Residential Development Plans

Assessor's Parcel 220-87-2
 74 EMERY STREET
 &
 Assessor's Parcel 220-87-3
 64 EMERY STREET
 Portsmouth, New Hampshire

**Re: Application for Site Plan Review - Planning Board Approval
Assessor's Map 220, Lots 87-2 and 87-3
74 and 64 Emery Street
Altus Project P4916**

SHEET NUMBER:
C - 1

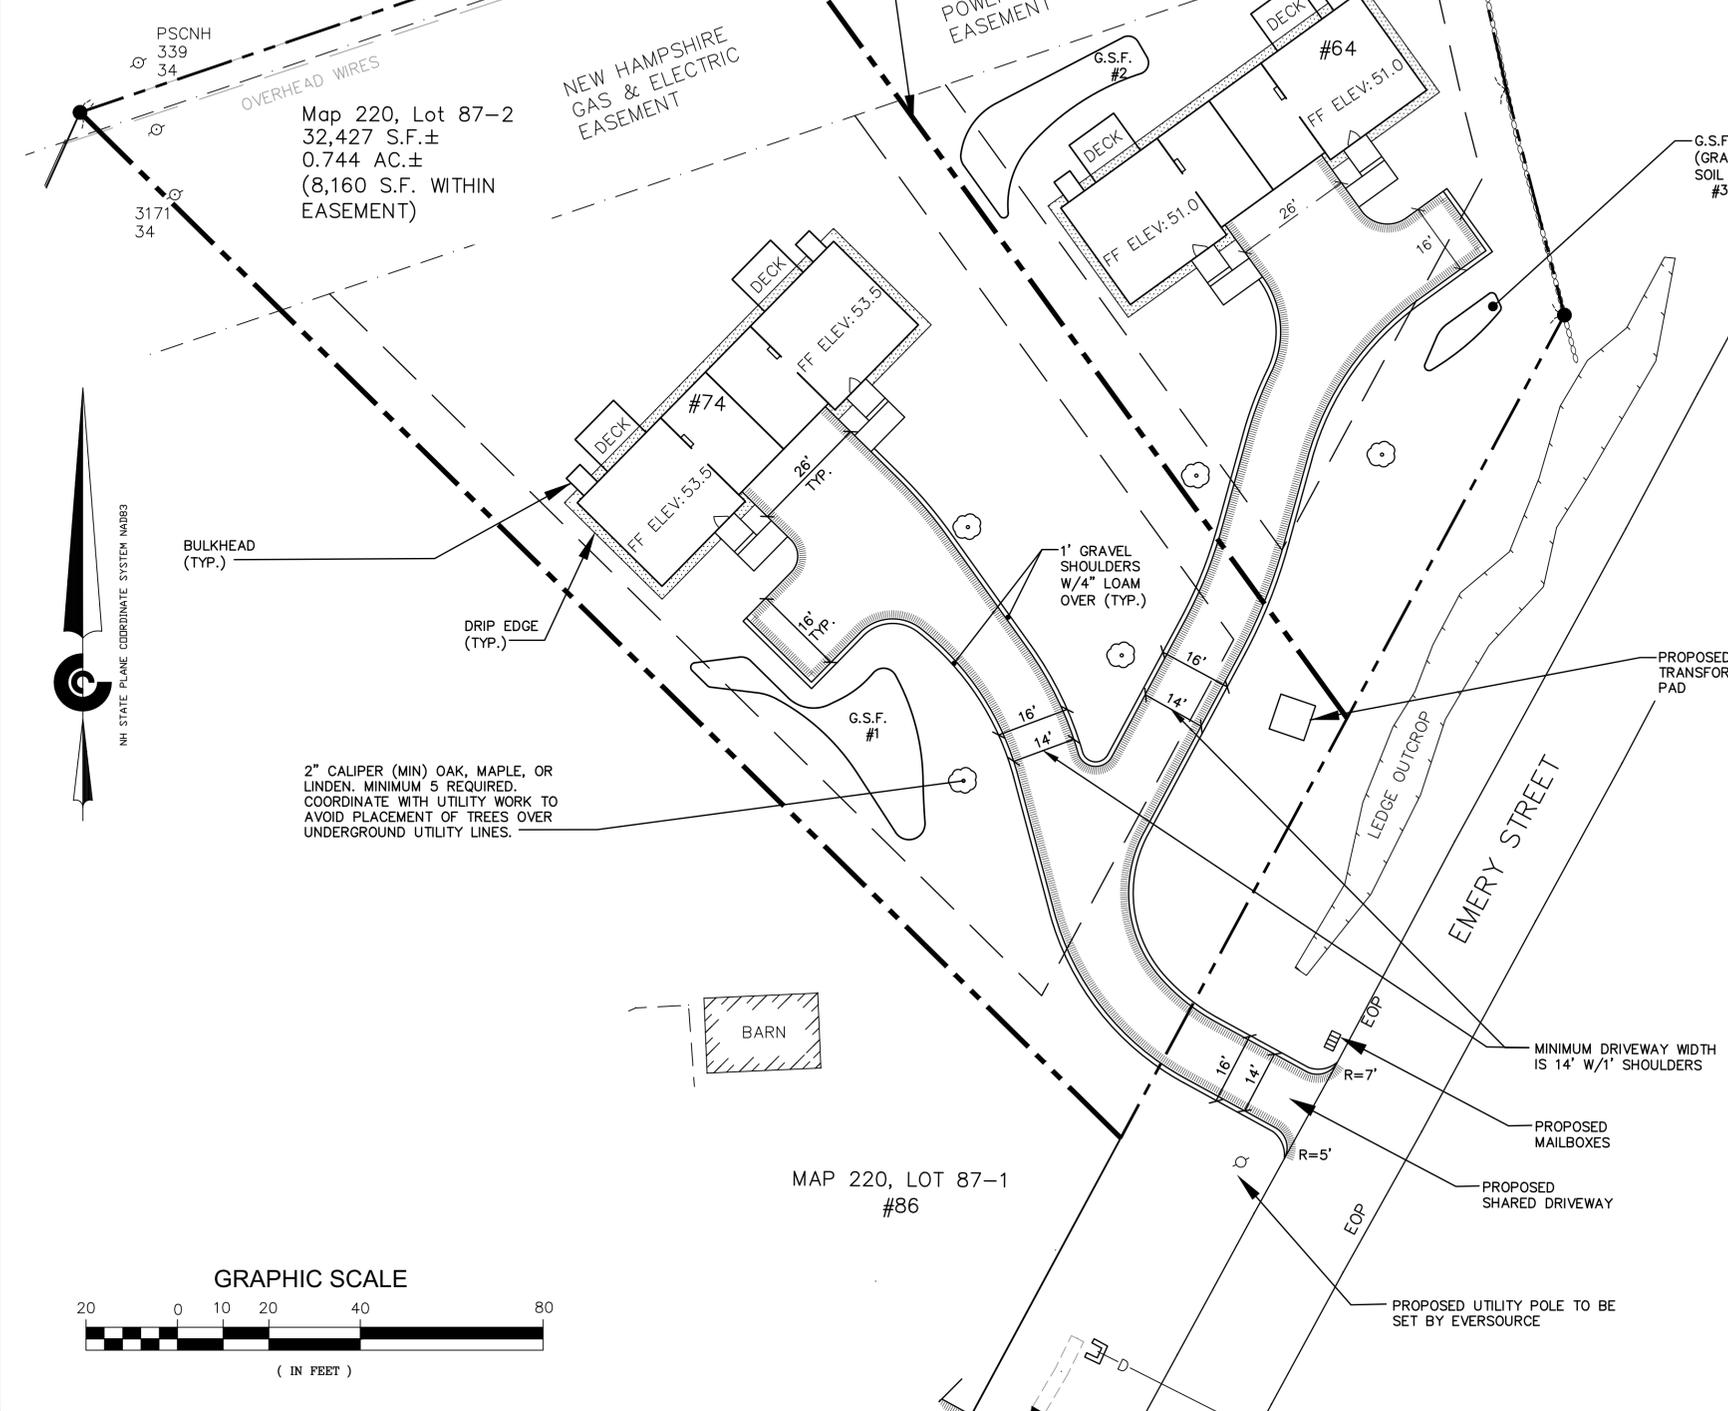
1. *Applicant shall show outline of proposed stormwater areas on the site plan so that it is clear to future homeowners.*

Response: The driveway width has been reduced to 14' indicated.

7. *Applicant shall provide a landscaping plan that includes limits of clearing, loaming and seeding.*

Response: The stormwater areas have been added to the site plan, sheet C-1.

Response: As discussed at TAC, a minimum of 5 trees are required and are shown on the site plan. All other disturbed areas will be lawn.

SHEET NUMBER:
C - 2

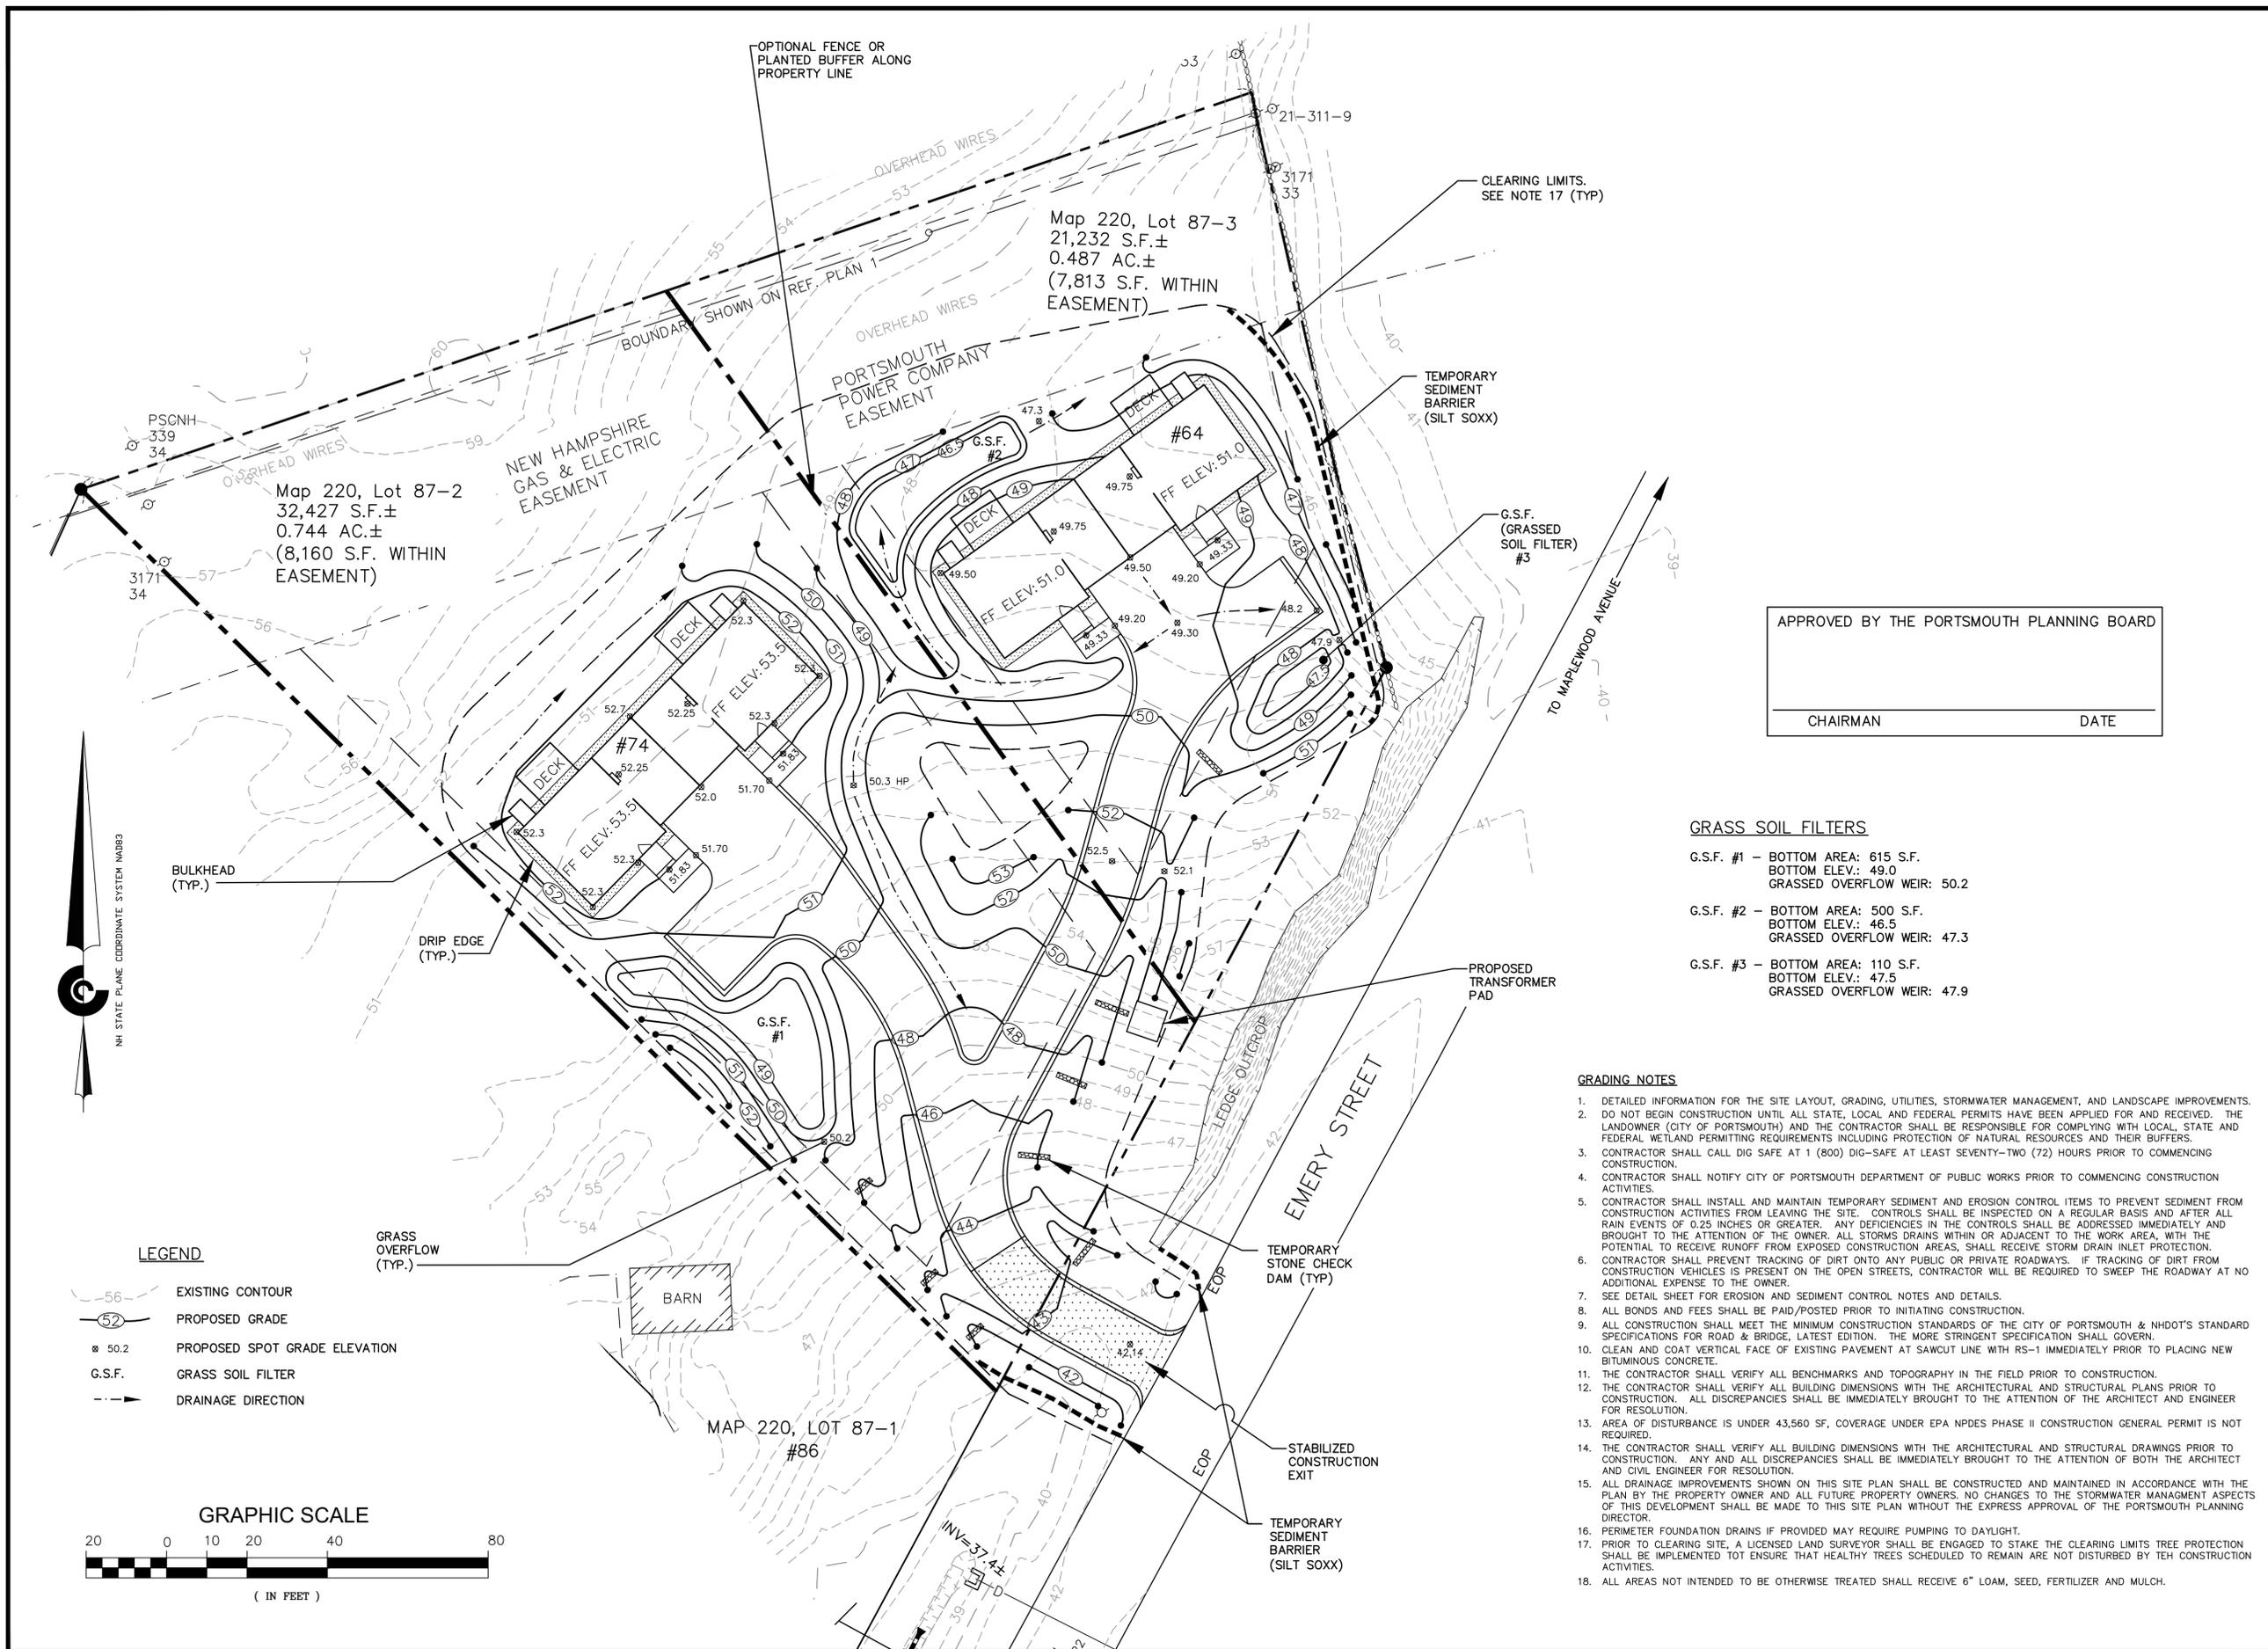
9. *Drainage and grading shall be updated and clarified to address TAC comments and approved by Planning and DPW staff prior to Planning Board review.*

Response: Temporary check dams are shown on the grading plan.

Response: The grading plan has been updated and is submitted for final approval.
